RECEIPT DATE: 12/14/18      **ONSITE SEWAGE DISPOSAL SYSTEM**      P 564096  
 APPROVAL DATE: 12/3/19      **PERMIT:**      **REPAIR**      A \_\_\_\_\_  
 PROPERTY ADDRESS: 18950 Windsor Forest Road  
 SUBDIVISION: \_\_\_\_\_ LOT: \_\_\_\_\_ TAX ID: 04-323521  
 CONTRACTOR: Fogle's Septic Clean Inc.      EMAIL: kim@foglesinc.com  
 CONTRACTOR ADDRESS: 580 Obrecht Road, Sykesville, MD 21784      PHONE: 410-795-5670  
 PROPERTY OWNER: Rob Scranton      EMAIL: \_\_\_\_\_  
 OWNER ADDRESS: 18950 Windsor Forest Road, Mount Airy, MD 21771      PHONE: 410-977-1725

## NOTICE OF VIOLATION

ON SITE SEWAGE DISPOSAL SYSTEM DESIGN PLAN  
PARCEL B  
WINDSOR FOREST  
PLAT No. 22269  
18950 WINDSOR FOREST ROAD  
FOURTH ELECTION DISTRICT  
HOWARD COUNTY, MARYLAND  
SCALE: 1"=50' DECEMBER 2018

**RE:** Septic permit approval for tie-in from barn

# DRIP DISPOSAL SYSTEM

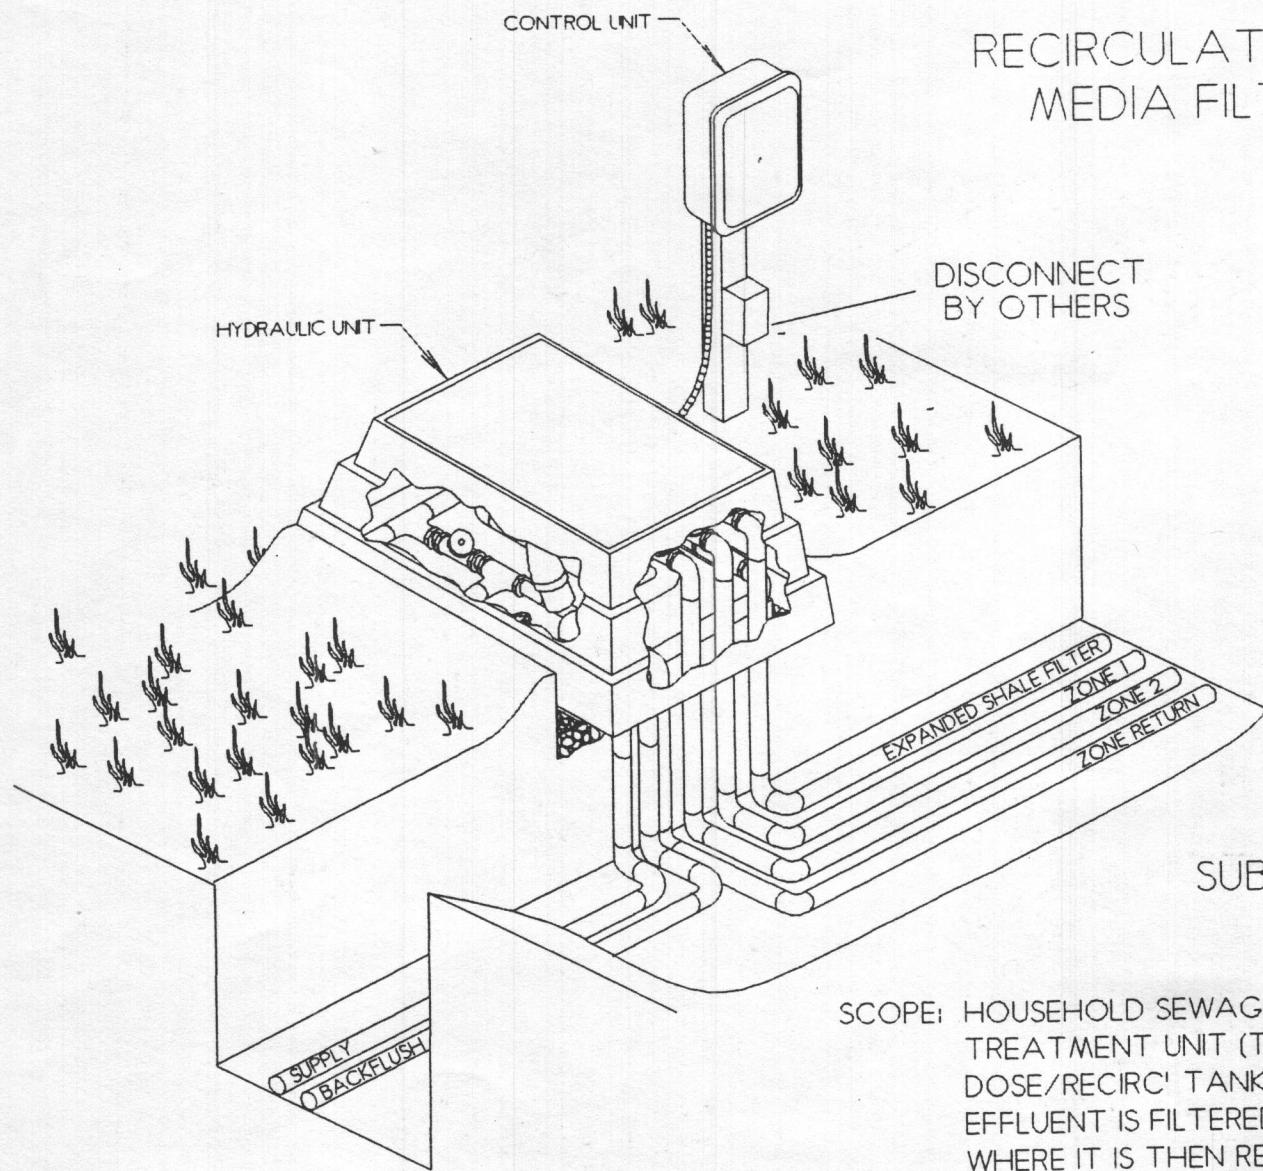
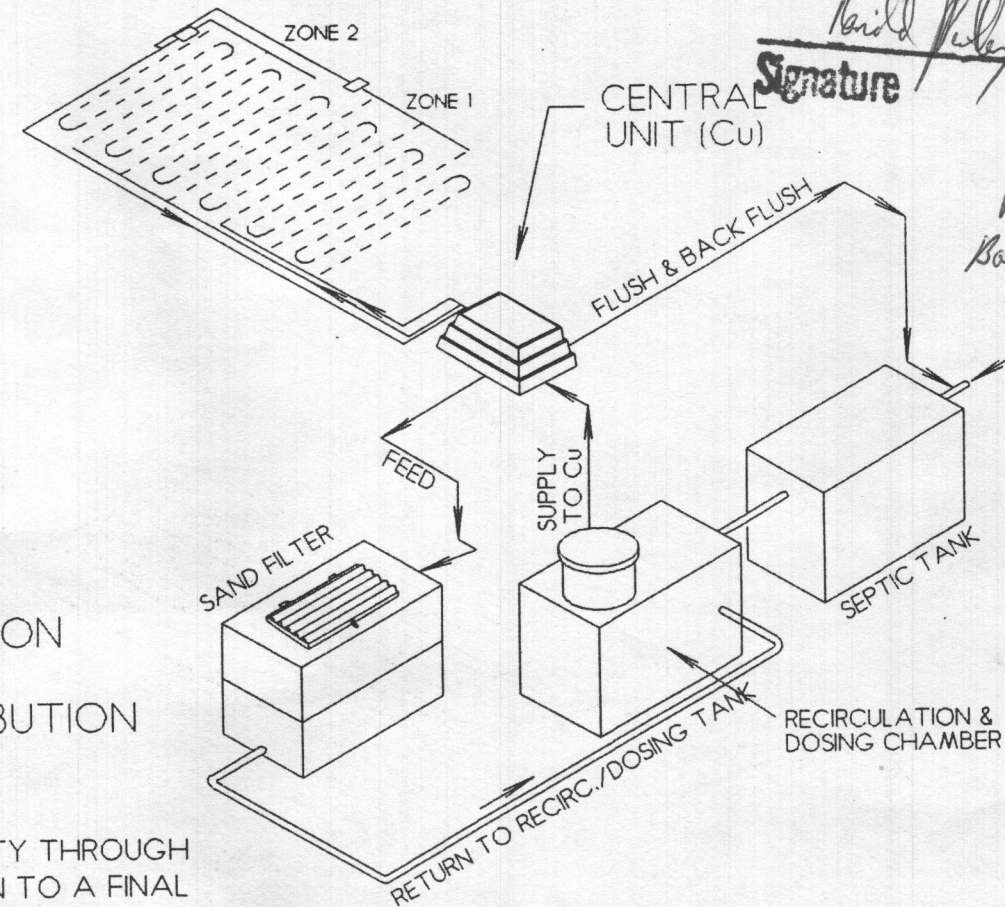
Plan OK except  
Barry Glotfelty requires  
900gpm (double modular)  
sand filter as  
mentioned in plan  
PP 3/13/97

Revised Plans  
March 24, 1997  
contain larger sand filter  
requirements - use  
those plans PP 4/8/97
